HISTORIC AND DESIGN REVIEW COMMISSION

HDRC CASE NO: 2022-428
ADDRESS: 1614 E HOUSTON ST
LEGAL DESCRIPTION: NCB 577 BLK 16 LOT 5
ZONING: RM-4, H
CITY COUNCIL DIST.: 2
DISTRICT: Dignowity Hill Historic District
APPLICANT: William Brewer/Done Right Construction DBA
OWNER: GOFORTH DERETHA & PATRICIA SCOTT
TYPE OF WORK: New construction of a 1.5-story, single-family structure
APPLICATION RECEIVED: February 27, 2023
60-DAY REVIEW: Not applicable due to City Council Emergency Orders
CASE MANAGER: Claudia Espinosa

The applicant is requesting conceptual approval to construct a 1.5-story, single-family structure.

DATE:
4/4/23
SCALE:
SHEET:

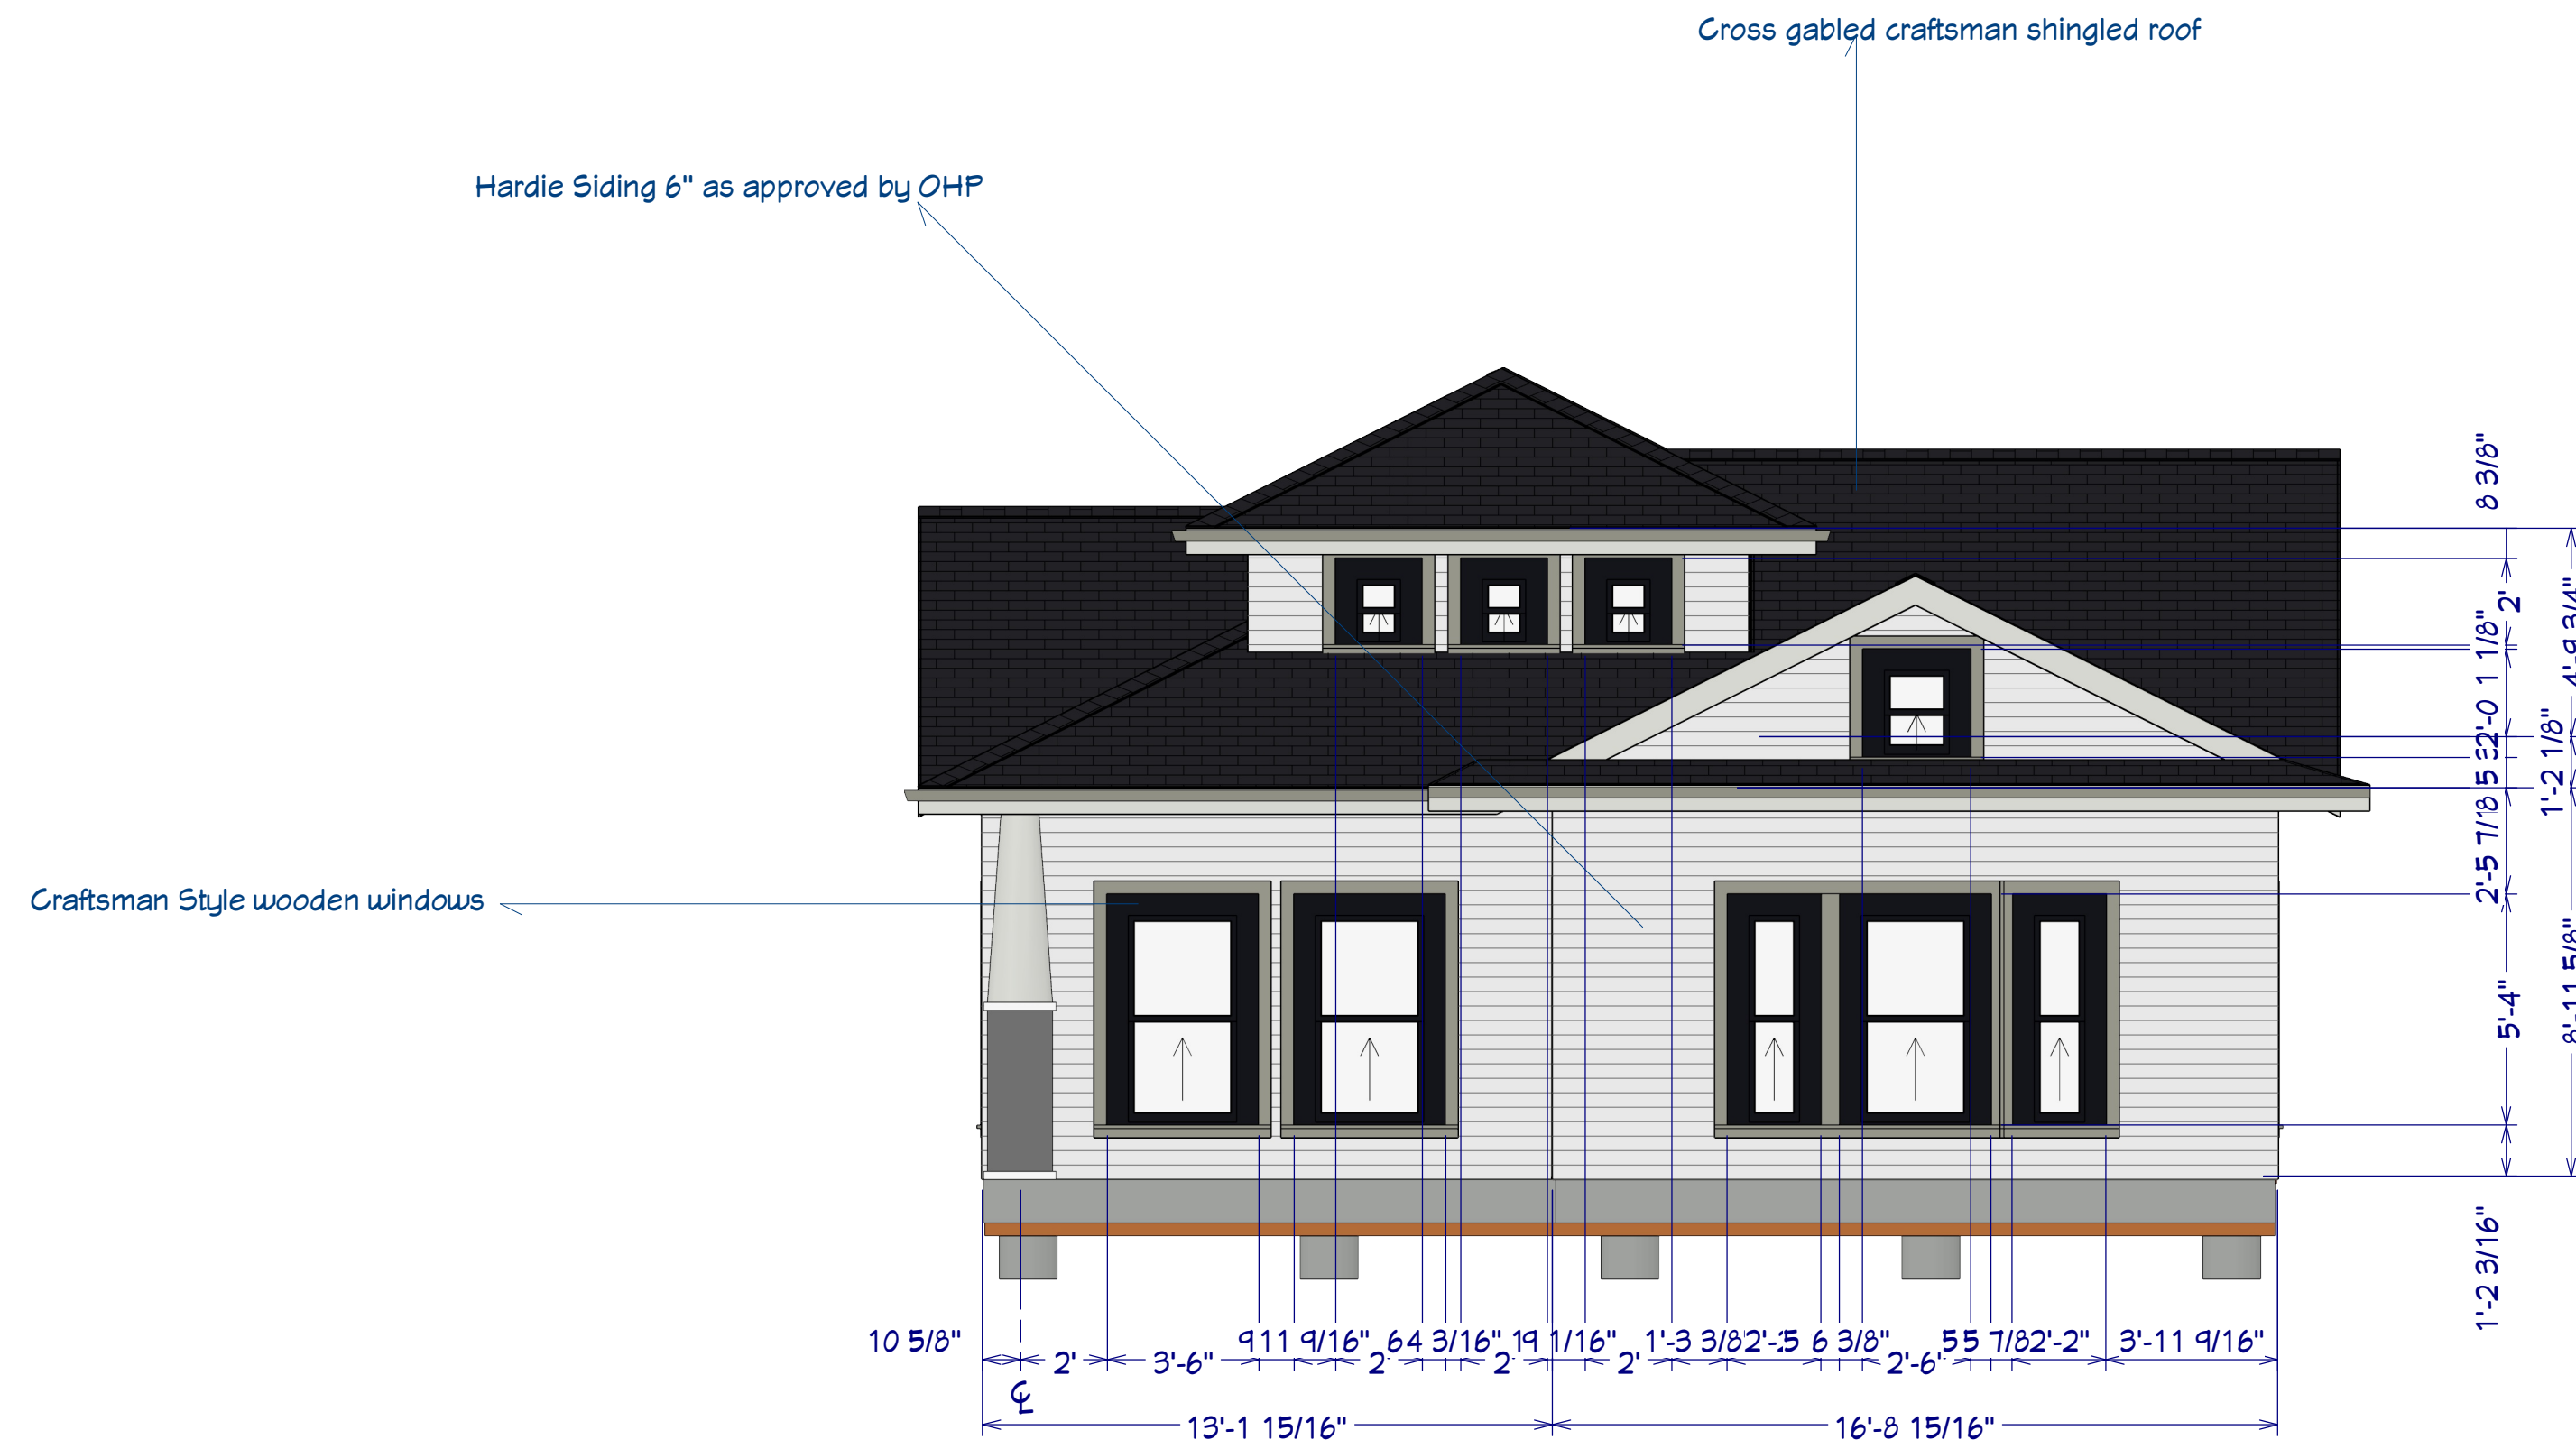
- e. **GENERAL DESIGN** – As stipulated at the time of demolition approval, the applicant must propose a front elevation that is a reconstruction of the original façade. The original house featured a low, cross gabled roof with inset front porch and side entry. The proposed design includes an inset porch at a similar location and a recreation of the original design as stipulated. The proposed roof form is compatible in comparison to the original structure. Staff further finds that a side-facing entry is appropriate and is consistent with the recreation of the front façade as stipulated by the HDRC Commission. The existing driveway, walkway and fencing will remain.

- h. **PORCH RECONSTRUCTION** – The original front porch form featured a side entryway, two sashed windows, and four wrought iron columns. Additionally, the front porch extends beyond the front façade projection and wraps beyond the front façade to the east. The applicant has proposed to reconstruct the porch to include the side entryway, two sashed windows and one porch column. Staff finds the proposed front porch to be inconsistent with reconstruction of the front porch as required by the HDRC. Staff finds that the installation of additional columns will more closely reflect the appearance of the existing front porch and that the footprint of the front porch should match the original layout and dimensions.

- m. RELATIONSHIP OF SOLIDS TO VOIDS – Guideline 2.C.i for New Construction stipulates that new construction should incorporate window and door openings with a similar proportion of wall to window space as typical with nearby historic facades. Windows, doors, porches, entryways, dormers, bays, and pediments shall be considered similar if they are no larger than 25% in size and vary no more than 10% in height to width ratio from adjacent historic facades. The applicant has proposed a fenestration pattern on the front façade that features a side entryway and double hung windows that are reflective of the original structure, staff finds this to be appropriate. The fenestration pattern on the remaining elevation consists of double-hung windows, a sliding door, and wooden doors. Staff finds that the applicants proposed fenestration to feature traditional proportions and window configurations commonly found in the district.

- ii. That the applicant updates the proposed elevations to feature a front porch that more closely matches the footprint, dimensions, and appearance of the existing front porch and submits the updated drawings to staff for review prior to returning to the HDRC based on finding h.

SITE PLAN

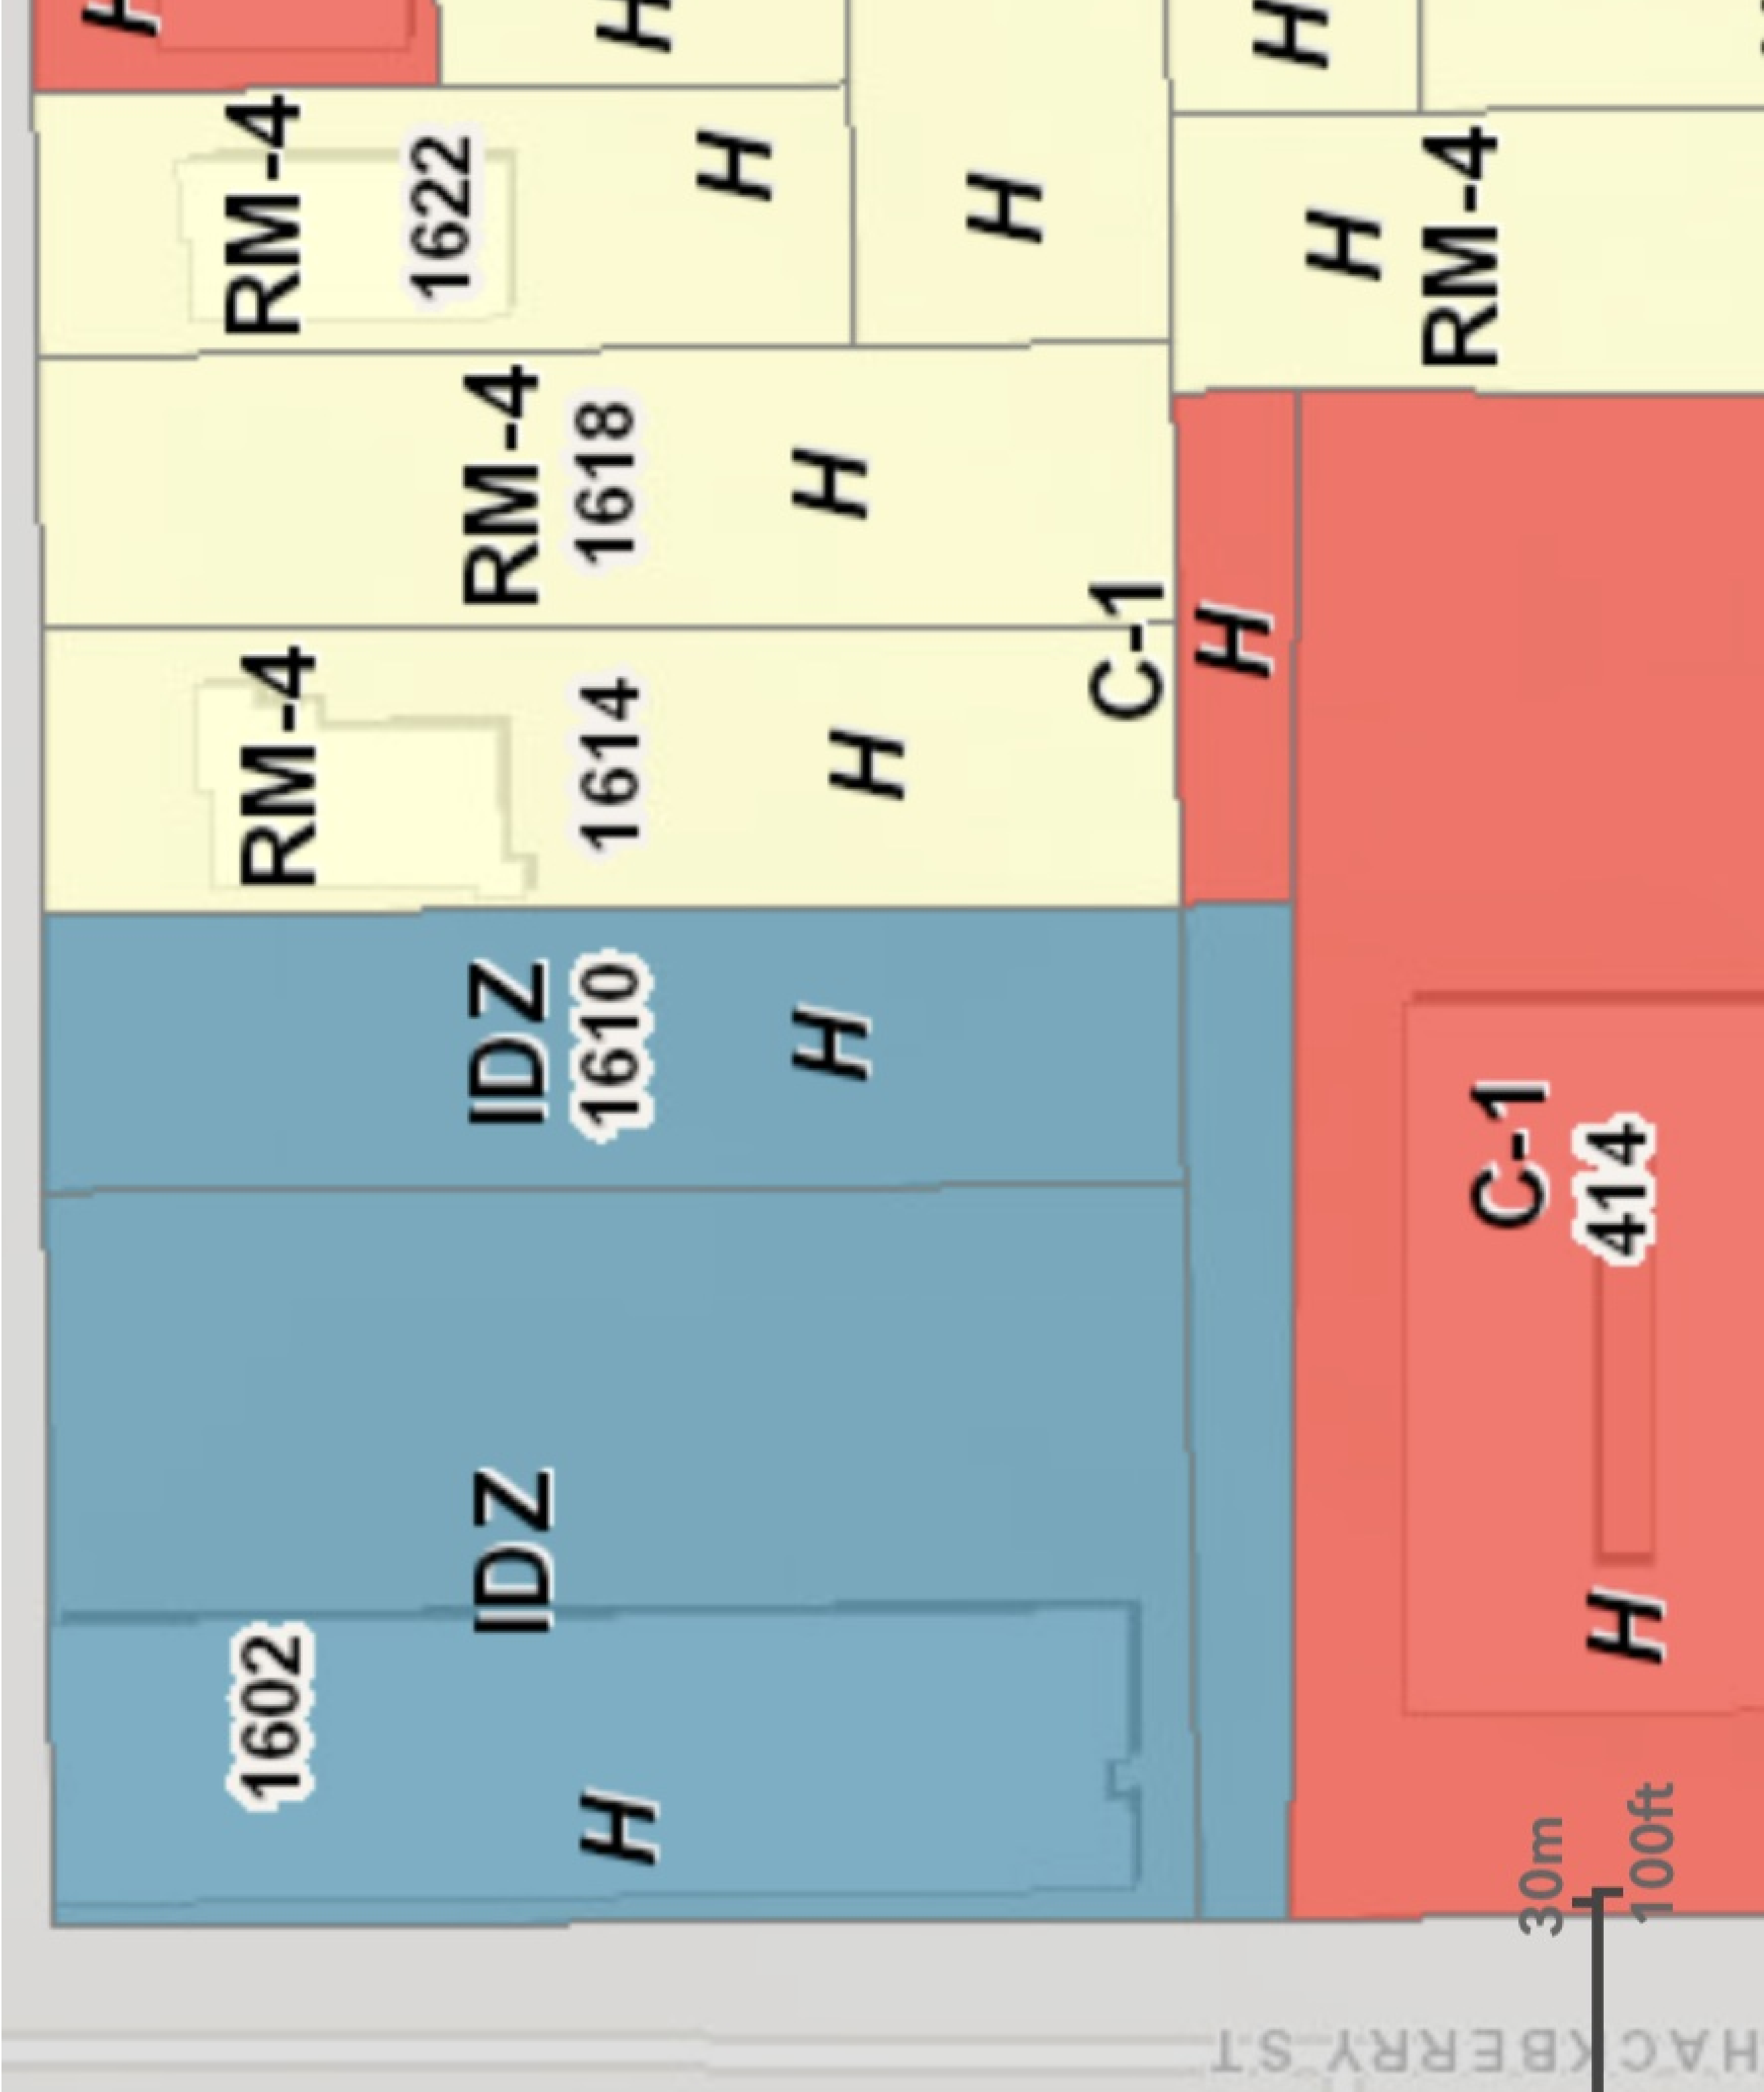
- f. **SETBACKS & ORIENTATION (HOUSTON)** – According to the Guidelines for New Construction, the front facades of new buildings should align with the front facades of adjacent buildings where a consistent setback has been established along the street frontage. Additionally, the orientation of new construction should be consistent with the historic examples found on the block. The applicant has indicated that the structure will be in the same location as the previous structure, which is consistent with the adjacent historic structure located to the east. The applicant has expressed that the adjacent properties feature a setback of 24.7' as shown in the provided site plan. At this time, the applicant has provided a detailed site plan that shows the location of the neighboring structure. Staff finds that the proposed front setback is generally appropriate. If approved, the plan will require a variance from the Board of Adjustment for placement on the west property line.

- j. **LOT COVERAGE** – Guideline 2.D.i for New Construction stipulates that building to lot ratio for new construction should be consistent with adjacent historic buildings. Limit the building footprint for new construction to no more than 50 percent of the total lot area, unless adjacent historic buildings establish a precedent with a greater building to lot ratio. Staff finds the proposal consistent with the Guidelines, per the submitted site plan.

- iii. That the applicant meets all setback standards as required by city zoning requirements and obtains a variance from the Board of Adjustment if applicable.
